MEMORANDUM

Subject: Review of Sourz HVR, Inc. Evaluation of Impacts to Groundwater Resources – Lake County UP 21-10 and IS 21-10

Independent Water Use Analysis and High Valley Aquifer Impact Study –
Sourz HVR Major Use Permit [UP-21-10. Initial Study [IS21-10]

Figure 1. Depth of water (feet bgs) recorded at Well #4 from 1961 to 2020.

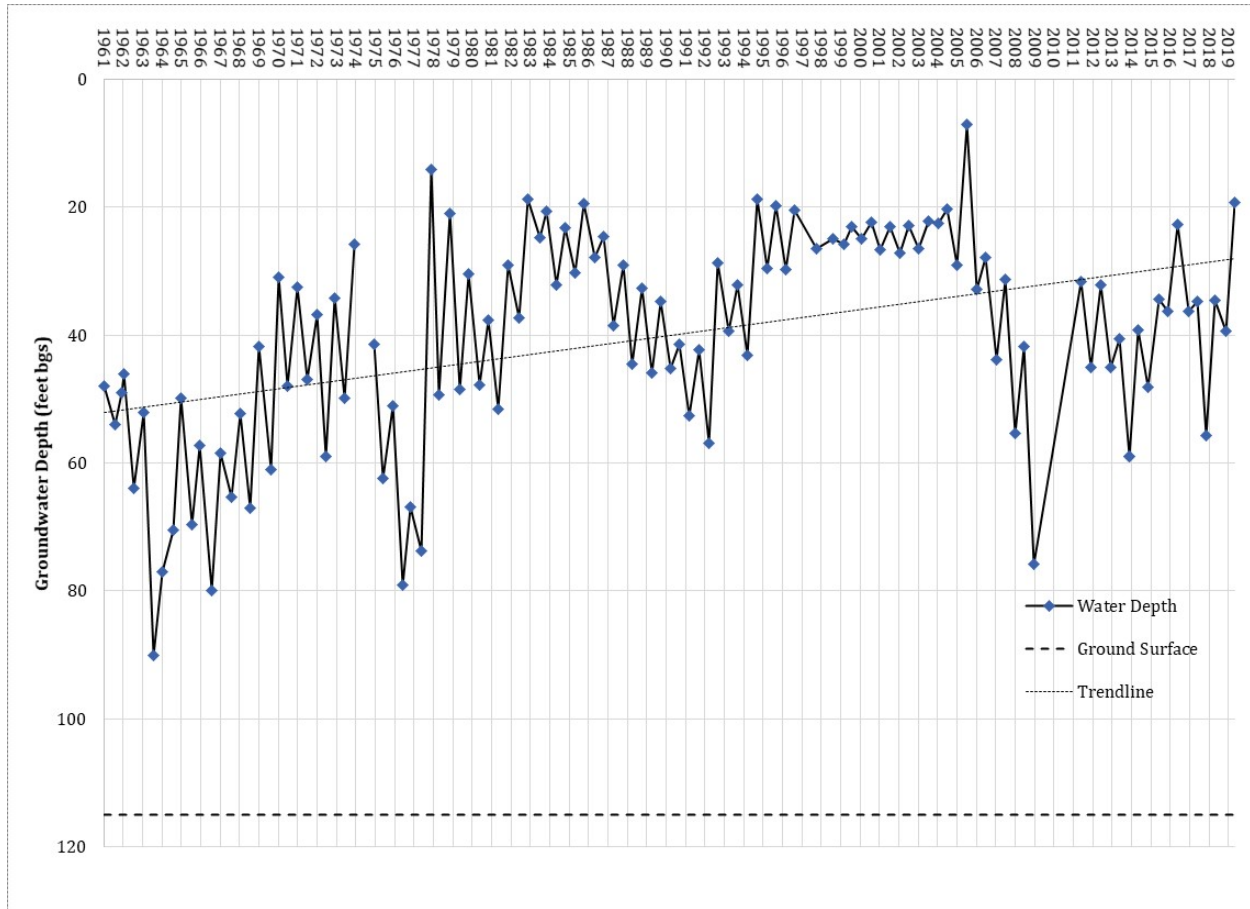
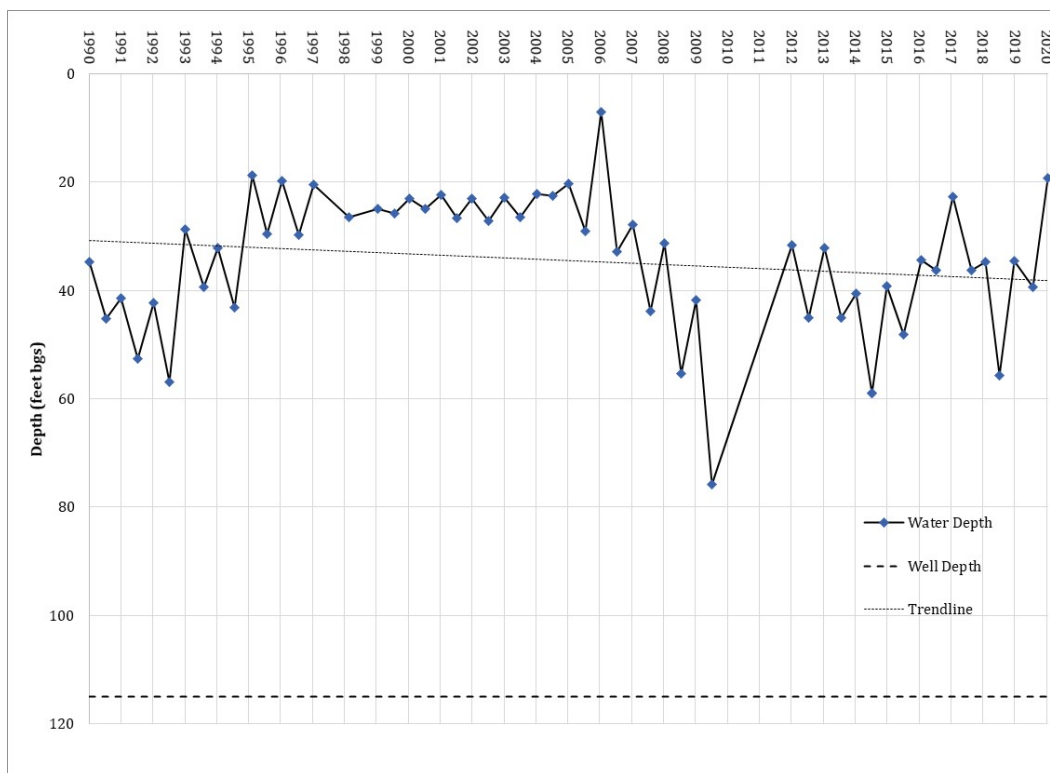
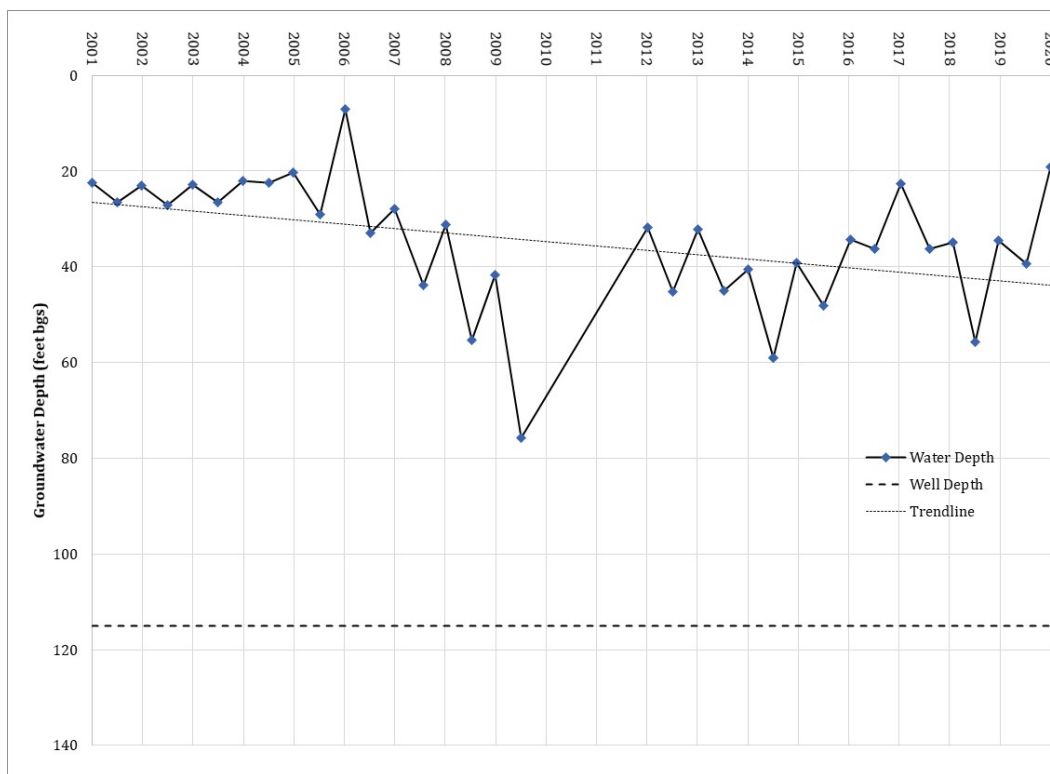
Also not discussed in the IS/MND, TM, or the Revised TM, is that Well #4 is a California Statewide Groundwater Monitoring (CASGEM) Program monitoring well (CASGEM Well ID #35927) that has been used to track and monitor seasonal and long-term groundwater elevation trends in the High Valley Groundwater Basin since 1961. Groundwater elevations in the well have been recorded almost every March and October since 1961. CASGEM identifies the monitoring entity as the Lake County Watershed Protection District. Although the general trend in groundwater depth, in feet bgs, appears to have been increasing since the well was drilled, it has been trending downward over the last 10 to 20 years (Figure 1 through Figure 3). This data, accordingly, contrasts with the data provided in the EBA GAS that seems to suggest the Basin has ample storage and recharge capacity.²

Although not discussed in the IS/MND, the Revised TM included a discussion regarding recharge during an average year, but lacked any discussion or analysis of recharge during a dry year or multiple dry years. For example, the lowest annual precipitation on record at the gage used by the EBA GAS (<https://wrcc.dri.edu/cgi-bin/cliMAIN.pl?ca1806>) occurred in 1976 and was 8.17 inches. Using 8.17 inches of precipitation to represent a dry year and the methodology provided by EBA GAS, there would be a recharge deficit of 407.7 acre-feet during a dry year. The greatest drawdown in Well #4 occurred in October 1976, at 79 feet bgs.
